TOWNSHIP OF ABINGTON

ADMINISTRATIVE CODE AND LAND USE COMMITTEE

A G E N D A

June 6, 2018

PLAN OF LOT LINE CHANGE
PREPARED FOR
TAX BLOCK 33 UNITS 5 & 41

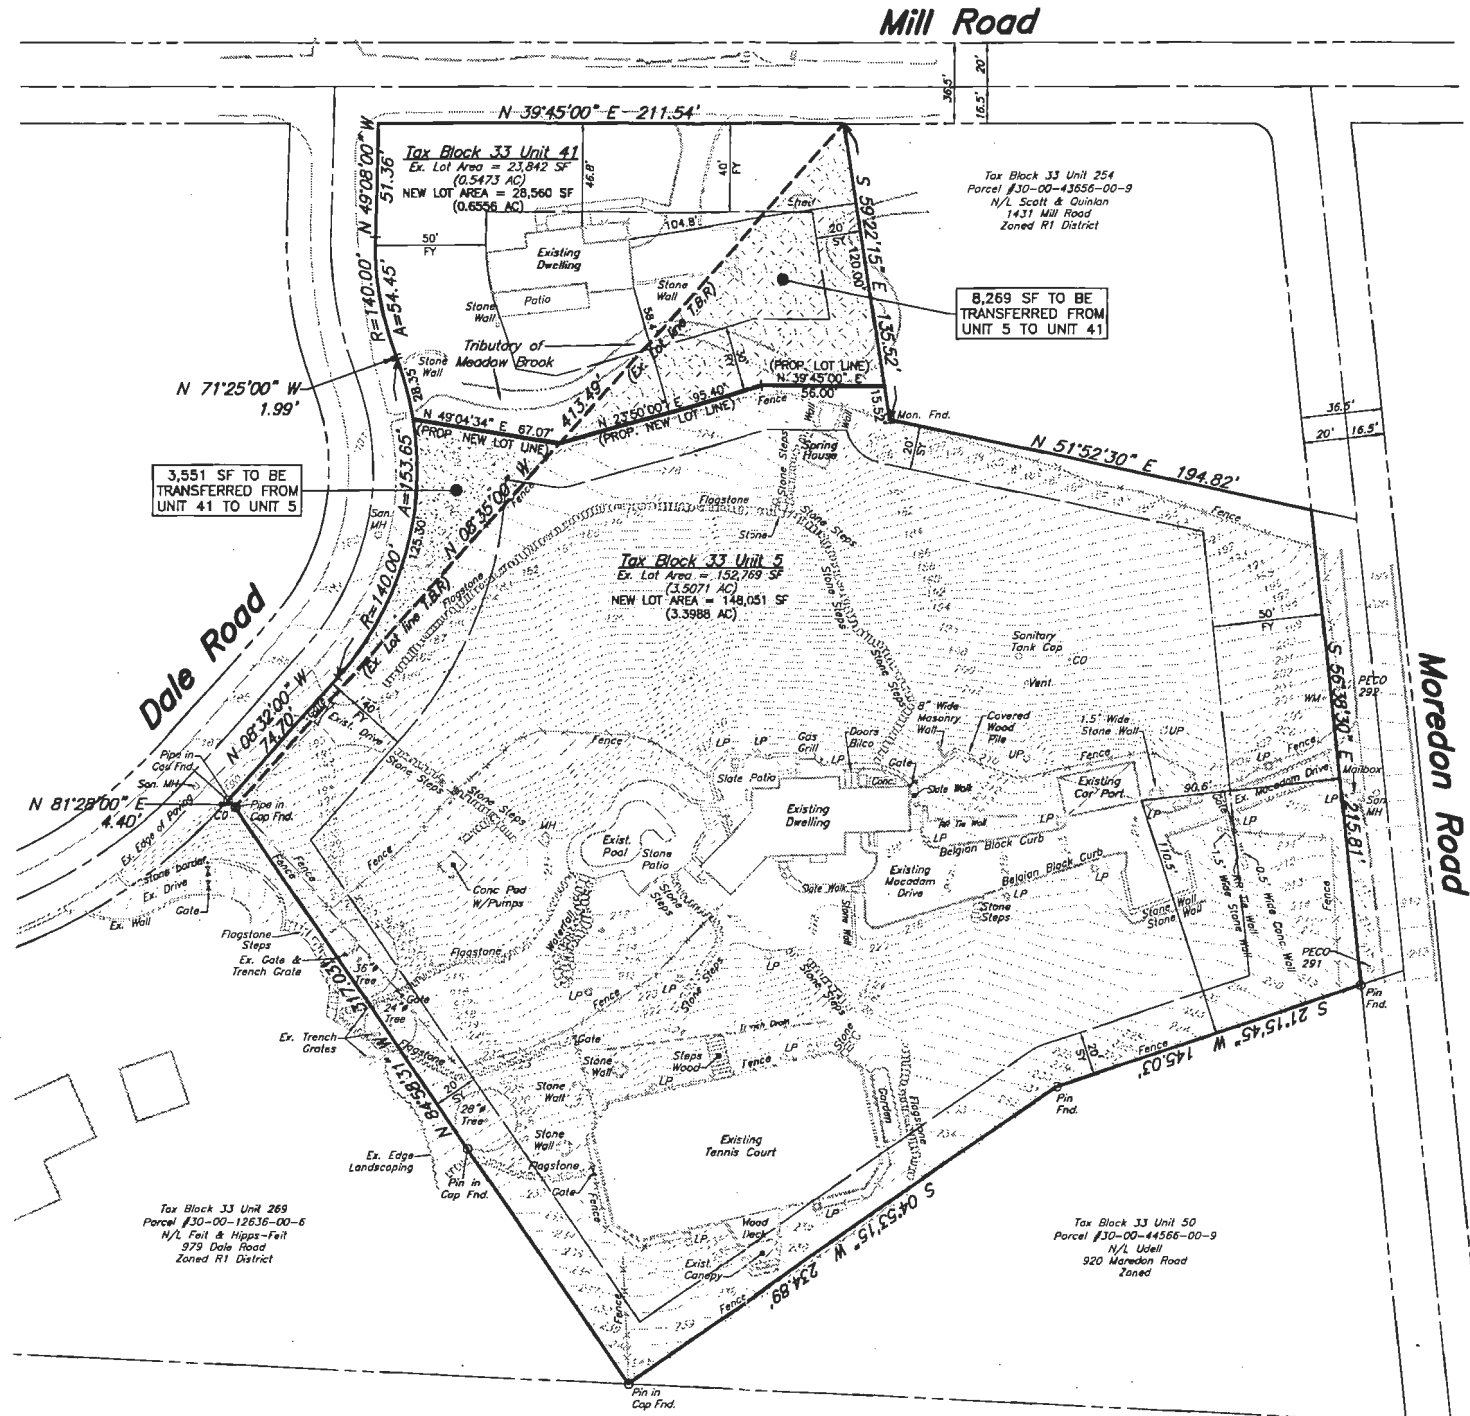
7. The project engineer has the building envelopes for 1407 Mill Road correctly plotted. Both properties now have dual frontage; however, 936 Moredon Road is not a corner property and Section 302, Figure 3.1 allows for the second front yard of a corner property to be reduced to 40 feet. The front yard setback on Dale Road should be increased to 50 feet.

11. The right-of-way width for Dale Road is not shown on the plan and must be added.
12. The Abington Township application number SD-18-01 shall be added to all plan sheets.

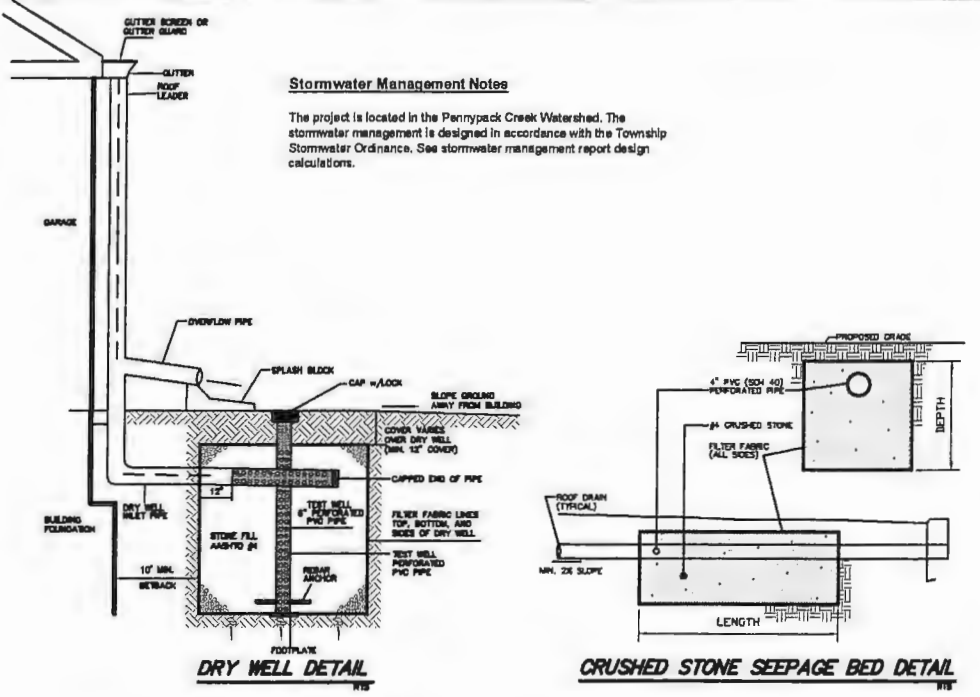
18. The "Crushed Stone Seepage Pit" detail on sheet 3 does not appear to apply to the project. The detail must be removed from the plan.
19. Specific elevations for Lots 2 & 3 must be added to the dry well detail on sheet 3. This includes bottom and top of stone, and inlet pipe insert.

Sheet 3 of 4 – A note should be added to state that all sanitary sewers and appurtenances shall conform to the current regulations and standards of the Township of Abington.

Sheet 3 of 4 - The proposed sewer line for Lot No. 2 should not connect into the sanitary sewer main in Kimball Avenue. The lateral sewer shall be connected directly into the existing Manhole No.1913F. (See enclosed construction detail). The size of the pipe is not required to be 6" and should conform to the requirements of the Plumbing Code. (The pipe material shall be Ductile Iron Pipe within the road Right-of-Way)

Sheet 3 of 4 - The proposed sewer line for Lot No. 3 should not connect into the sanitary sewer main in Kimball Avenue. The lateral sewer shall be connected directly into the existing Manhole No.5196 located in Windsor Avenue. (See enclosed construction details. The pipe material shall be Ductile Iron Pipe within the road Right-of-Way)

Sheet 3 of 4 – Our records indicate that the existing home's sanitary sewer lateral is located at Station 0+45.7 along Kimball Avenue, measured upstream from MH No.1913F. The house sewer line does not include a bend, but runs straight from the home to the street. Please verify and revise the plan as required.
